MOORE RANCH URANIUM PROJECT RESPONSES TO:

NRC JULY 27, 2009 - AUGUST 18, 2009 SAFETY EVALUATION REPORT OPEN ISSUES

NRC SER OPEN ISSUES

JULY-AUGUST 2009

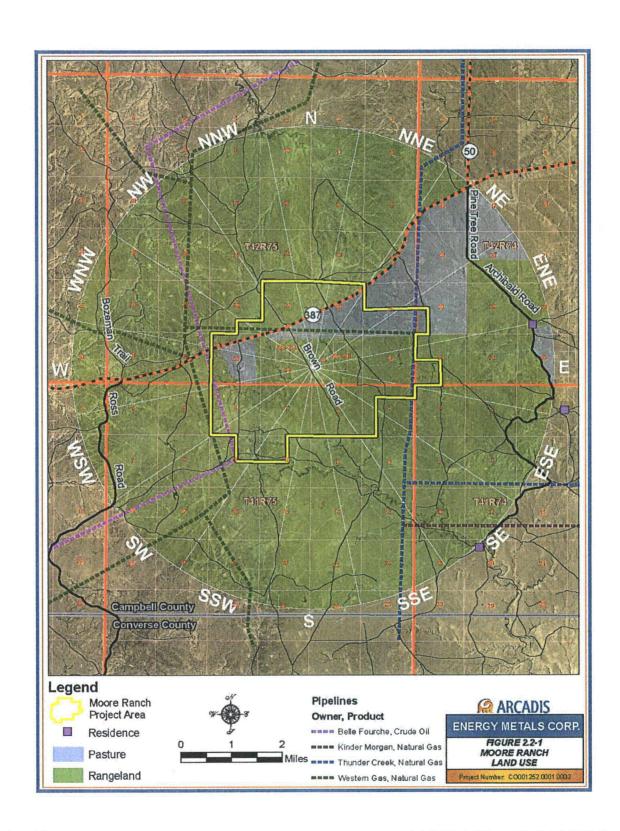
The staff notes that the applicant did not address the collection of crop samples or provide a justification for not collecting crop samples.

Crop sampling was not performed at the Moore Ranch Uranium Project because there are no crops currently being raised within the project area. Discussions with the land owner confirmed that crops have not been raised on pasture lands located within the project area since the late 1980's.

FIGURE 1

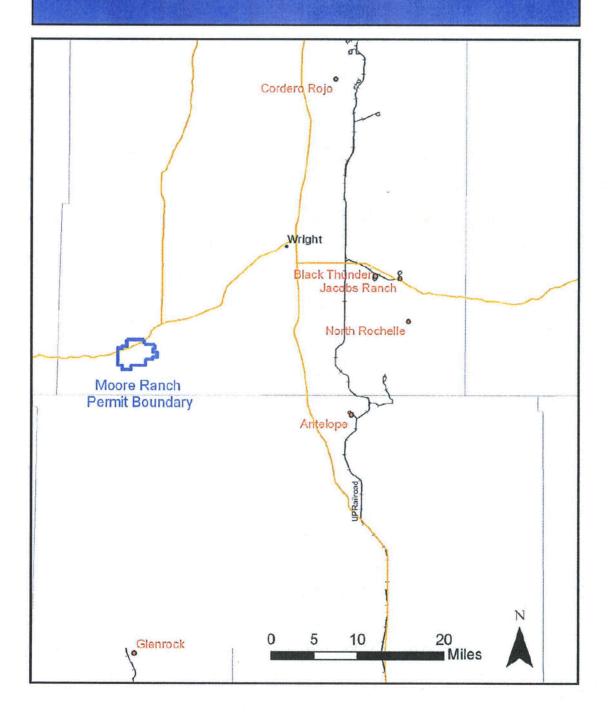
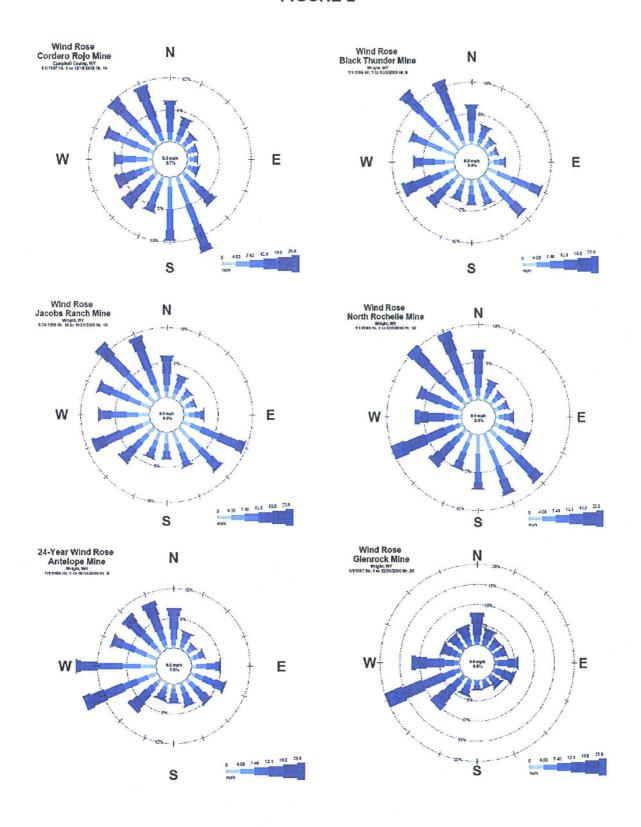
As per discussions in the November 23, conference call with the NRC, additional data from near by meteorological sites with in the Powder River Basin were compiled to support the use of the ACC site as a representative off-site meteorological data source in Section 2.5 of the Technical Report. A brief discussion describing the six coal mine meteorological stations used in the comparison is provided below. Figure 1 depicts the locations of the six meteorological stations and the location of the Moore Ranch Project. Wind roses for the six sites are presented in the attached Figure 2. Meteorological site summaries are provided for review in Appendix A. Based on the attached information the ACC site remains the most representative off-site data source that best represents meteorological conditions for the Moore Ranch site.

In an effort to establish uniformly trending wind patterns in the Powder River Basin (PRB), IML Air Science has compiled meteorological summaries and wind roses for a total of 6 coal mine meteorological stations in the PRB (including ACC). Figure 1 below shows the 6 mines and the Moore Ranch permit area. Meteorological summaries for these mines appear in Appendix A. Long-term average wind speeds at all sites except Glenrock Coal Company (GCC) range from 9.4 to 11.2 mph. GCC averages 14.8 mph due to the higher altitude and the funneling effect of the nearby Laramie Range.

Figure 2 illustrates a north-to-south trend in wind directions. The wind roses in Figure 2 should be examined from left to right, then top to bottom. From the northern PRB to the southern PRB, prevailing wind directions gradually shift from a northwest-southeast, bimodal flow to a predominantly west-southwesterly flow. In the northern part of the PRB, represented by the Cordero Rojo meteorological station, the northwesterly and southeasterly winds dominate. Farther south, the Black Thunder and Jacobs Ranch meteorological stations show an emerging west-southwesterly component. Farther south still, the North Rochelle meteorological station exhibits a more pronounced west-southwesterly component. Proceeding southward to ACC, one observes an even more prominent west-southwesterly wind component. The Glenrock Coal meteorological station, at the southern extreme of the PRB, shows the west-southwesterly winds to be dominant.

ACC was chosen as being representative of the Moore Ranch meteorology for several reasons. First, among the coal mines in the PRB, ACC lies closest to the Moore Ranch project. Second, given the north-to-south trend in wind directions throughout the PRB, the similar latitudes of the ACC and Moore Ranch sites should account for this trend. Third, the topography at ACC is very similar to the topography at Moore Ranch.

Miscellaneous Open Issue No. 4 No annual wind rose provided July 27 2009 Teleconference

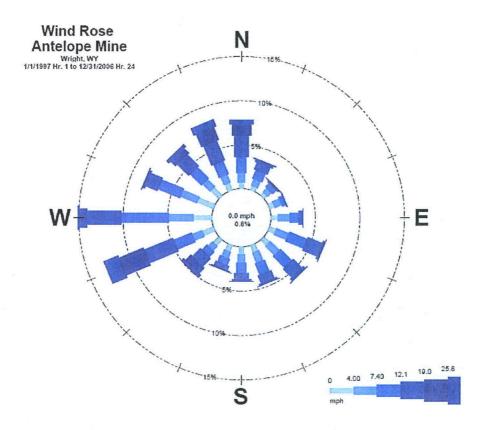
The applicant provides seasonal wind roses but did not provide an annual wind rose summary.

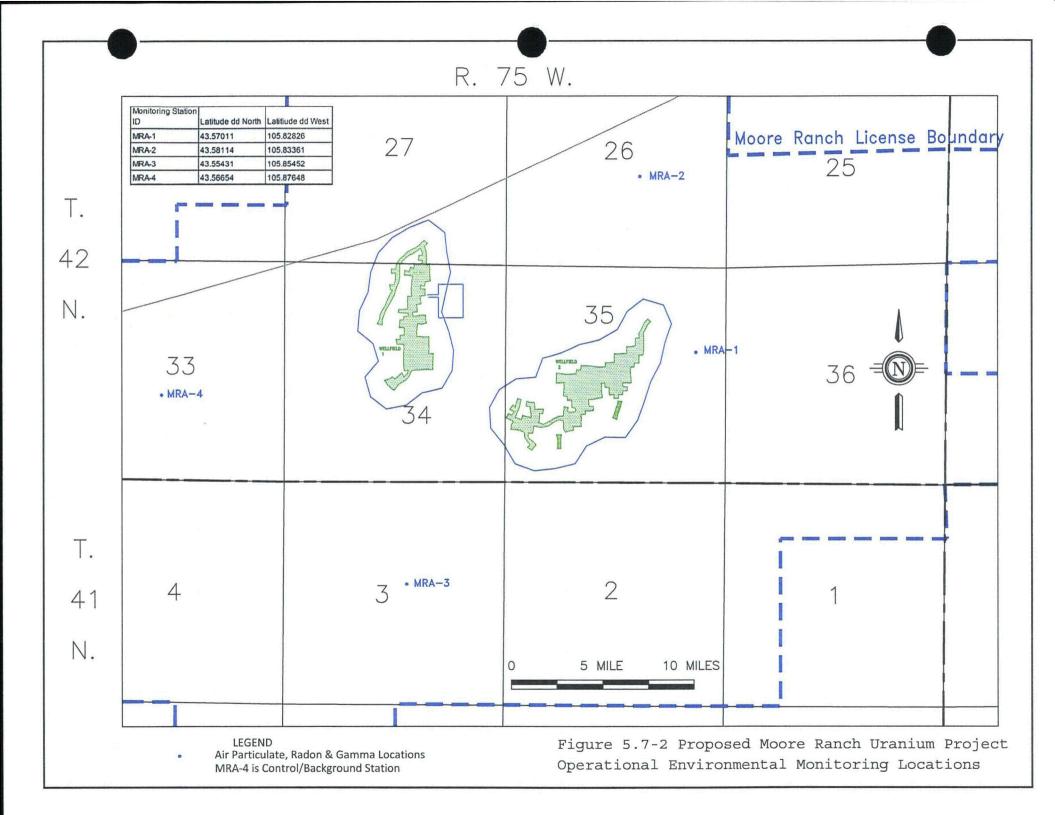
The applicant stated that the proposed locations of airborne particulate and radon daughter samples are depicted in Figure 5.7-1 of the Technical Report. The applicant provided a page with a title but no map or figures showing the proposed locations of airborne particulate and radon daughter sampling. The staff, therefore, cannot determine if the applicant has properly located the airborne particulate and radon daughter sampling stations in the facility in accordance with Regulatory Guide 8.25.

Airborne particulate levels at solution mines that employ vacuum dryers are very low since there are no emissions. The primary potential source of airborne uranium is during yellowcake packaging. This operation will be confined to the dryer room. The room will be closed and posted as an airborne radioactivity area during packaging. The proposed airborne uranium sampling locations for the Moore Ranch Central Plant are shown on Figure 5.7-1. Samples will be obtained using area samplers on a monthly frequency. For airborne radioactivity areas as defined in 10 CFR 20.1003, samples will be obtained using area samplers on a weekly frequency if workers occupy the area.
